Proposal for 05 series of amendments to UN Regulation No. 12 - protection of the driver against the steering mechanism in the event of impact

Submitted by the expert from the Netherlands *

The text reproduced below was prepared by the expert from the Netherlands, aiming to update the requirements concerning post-crash electrical safety in the event of frontal impact collision as proposed in Working Document ECE/TRANS/WP.29/GRSP/2021/18e. The modifications to the current proposal are marked in blue; bold for new or strikethrough for deleted characters.

Figure 4
Example of test method using DC power supply

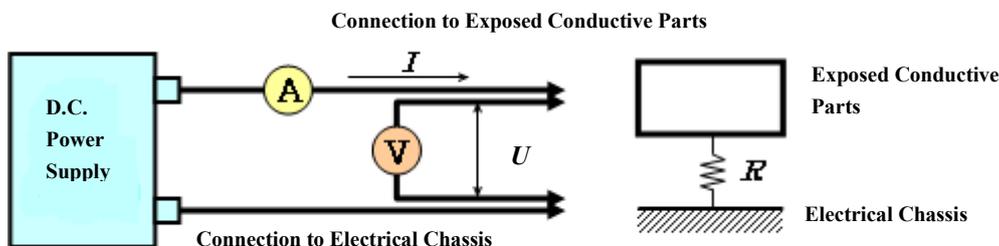
enclosure/electrical protection barrier) and the resistance is measured using a resistance tester that meets the specification as follows:

- (i) Resistance tester: Measurement current at least 0.2 A;
 - (ii) Resolution: 0.01 Ω or less;
 - (iii) The resistance R shall be less than 0.1 Ω .
- (b) Test method using DC power supply, voltmeter and ammeter.

The DC power supply, voltmeter and ammeter are connected to the measuring points (Typically, electrical chassis and electro conductive enclosure/electrical protection barrier).

The voltage of the DC power supply is adjusted so that the current flow becomes at least 0.2 A.

The current "I" and the voltage "U" are measured.

The resistance "R" is calculated according to the following formula:

$$R = U / I$$

The resistance R shall be less than 0.1 Ω .

Note: If lead wires are used for voltage and current measurement, each lead wire shall be independently connected to the electrical protection barrier/enclosure/electrical chassis. Terminal can be common for voltage measurement and current measurement.

Example of the test method using DC power supply, voltmeter and ammeter is shown below.

Figure 5

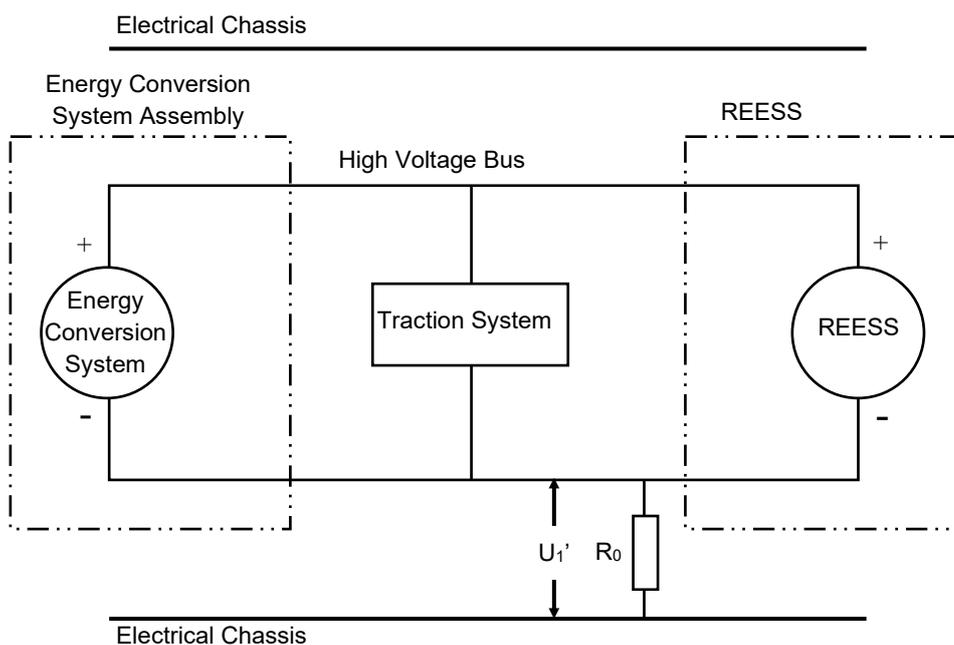
If U_1 is greater than or equal to U_2 , a standard known resistance (R_0) is inserted between the negative side of the high voltage bus and the electrical chassis. With R_0 installed, the voltage (U_1') between the negative side of the high voltage bus and the electrical chassis is measured (see Figure 5).

The electrical isolation (R_i) is calculated according to the following formula:

$$R_i = R_0 * U_b * (1/U_1' - 1/U_1)$$

Figure 6
Measurement of U_2'

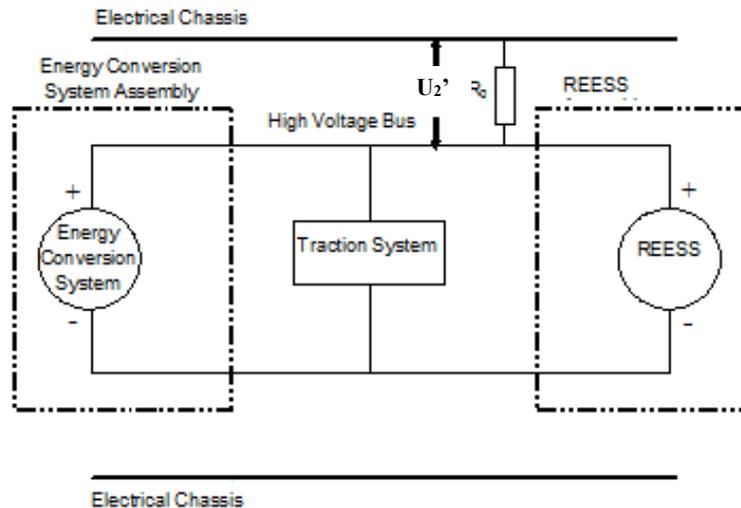
If U_2 is greater than U_1 , insert a standard known resistance (R_0) between the positive side of the high voltage bus and the electrical chassis. With R_0 installed, measure the voltage (U_2') between the positive side of the high voltage bus and the electrical chassis (see Figure 6 below). The electrical isolation (R_i) is calculated according to the following formula:

$$R_i = R_0 * U_b * (1/U_2' - 1/U_2)$$
